Access Compliance Report

Public Rights-of-Way

(Curb Ramps)

Intersection ID: 13787	Main Street: CHARLOTTETOWNE_AV	Cross Street: E_4TH_ST	Location: NW
ADA ID: 3325E4AB59CD	Ramp Type: Perp	Initial Pass/Fail: Fail	Overall Compliance: No
Severity Score: 13.75			
Codes/Mitigation Info/Possible Solution		Field Measurements/Component Compliance

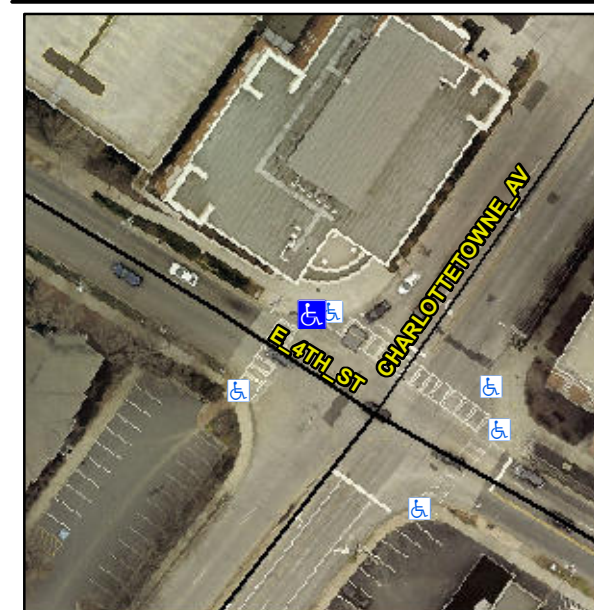
Not Found, R304.2.2

Compliance	Description	Data	Compliance	Description	Data
N/A	Ramp Length (in)	96.0	No	Ramp Slope (%)	10.4
Yes	Ramp Width (in)	59.0	Yes	Ramp XSlope (%)	4.5
N/A	Flare Type LT	N/A	N/A	Flare Type RT	N/A
N/A	Flare Slope LT (%)	N/A	N/A	Flare Slope RT (%)	N/A
N/A	Flare Traversable LT?	N/A	N/A	Flare Traversable RT?	N/A
N/A	Landing Length (in)	N/A	N/A	DWS Provided?	N/A
N/A	Landing Width (in)	N/A	N/A	DWS Contrast?	N/A
N/A	Landing Slope (%)	N/A	N/A	DWS Length (in)	N/A
N/A	Landing X Slope (%)	N/A	N/A	DWS Full Width?	N/A
N/A	Landing Curb? (Y/N)	N/A	N/A	DWS Offset (in)	N/A
N/A	Shared Landing?	N/A			
N/A	Gutter Ponding?	N/A	N/A	Gutter Slope (%)	N/A
N/A	Gutter Lip Ht (in)	N/A	N/A	Gutter X Slope (%)	N/A
N/A	Painted X Walk1?	Yes	N/A	Painted X Walk2?	N/A
	X Walk 1 Direction	To SW		X Walk 2 Direction	N/A
N/A	X Walk 1 Width (in)	120.0	N/A	X Walk 2 Width (in)	N/A
	X Walk 1 Slope (%)	6.1		X Walk 2 Slope (%)	N/A
	X Walk 1 X Slope (%)	5.0		X Walk 2 X Slope (%)	N/A

Remove & Replace Entire Ramp.
